UNITED STATES PATENT AND TRADEMARK OFFICE

10/635,694

Robert L. Memmen

Office Action Summary

FIG. 6

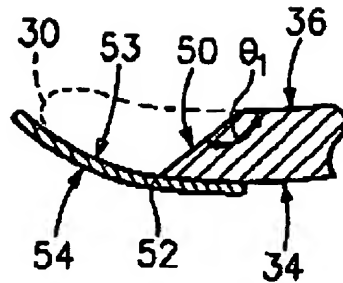
7. Claim 22 would be allowable if rewritten to overcome the rejection(s) under 35 U.S.C. 112, 2nd paragraph, set forth in this Office action and to include all of the limitations of the base claim and any intervening claims.

8. The following is a statement of reasons for the indication of allowable subject matter: the prior art of record of record does not teach or suggest: a method of restoring a Ti alloy turbine component which has lost first material from a damage site comprising:

applying a backing element to the component adjacent the damage site so that the deposited Ti based material builds up on the component and the backing element; and physically depositing a Ti-based material at least partially in place of the first material, wherein

the backing element has a first face;

the applying place a first portion of the first face along [the] a remaining intact leading surface of the component; and

the physically deposition deposits said Ti-based material along a second portion of said first face protruding beyond a lost leading edge of the intact leading surface,

in combination with the other claimed subject matter. See Figure 6, below.
